Mr. Michael Cunningham
Division of Reclamation, Mining and Safety -- Denver Office

June 20, 2017

RE: NOTICE OF DEFICIENCIES IN NOI FILE NO. P2016-020 (MD01)

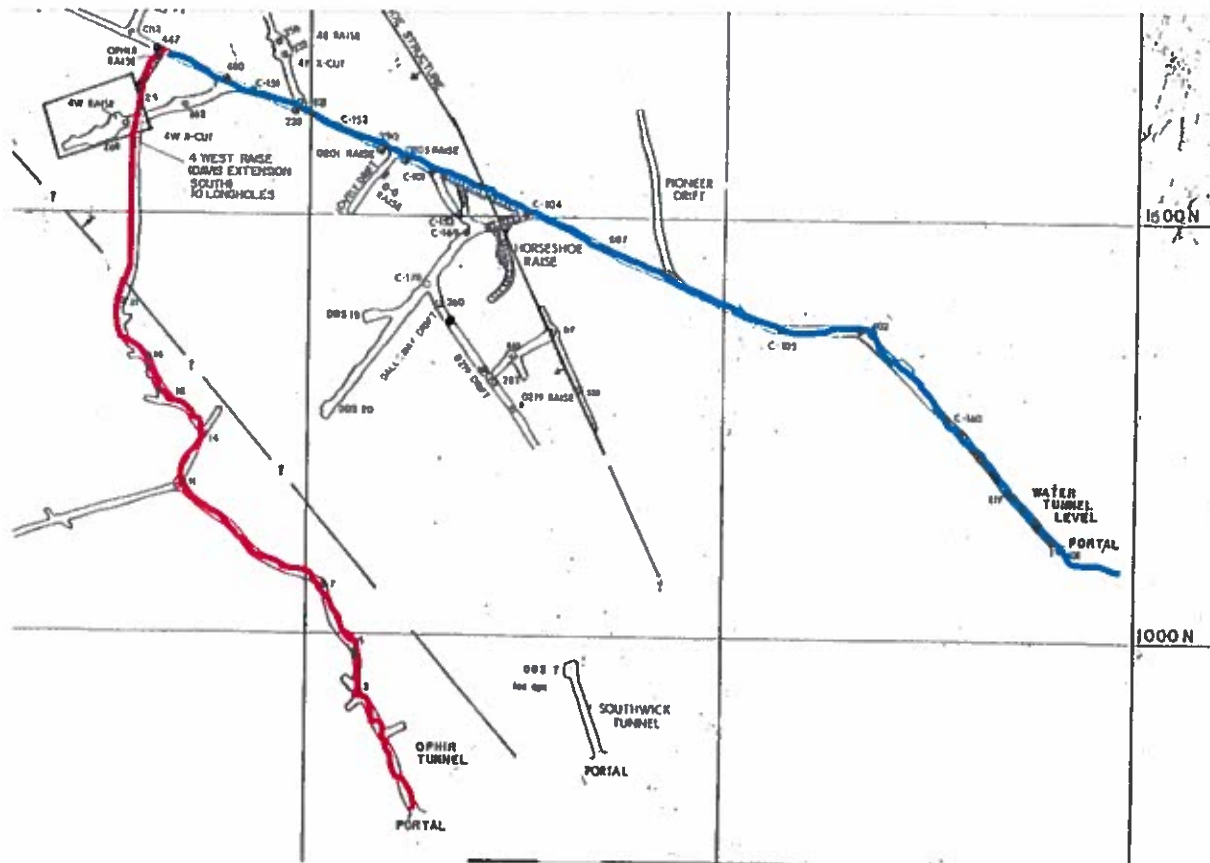
5. Please provide a map which shows the location of all proposed surface disturbance (drill pads, trenching, road improvements, portal rehabilitation) relative to the London Mine. In addition, provide a map of the London Mine workings which illustrates the pathway water will take from the Ophir Tunnel to the discharge location.

This figure shows in black outline the area of disturbance for the drill pads, in red the line of the trenching planned from the wells to the Ophir Portal, in blue the road improvement area, and in green the portal rehabilitation as proposed.

This figure depicts the pathway of the water through the Ophir Tunnel workings (in red) to join with the main flow on the Water Tunnel level (in blue) which emerges at the Portal and is treated using flocculation (as needed), sedimentation, and pH adjustment pursuant to our Consent Decree with CDPHE and the discharge permit CO-0038334.
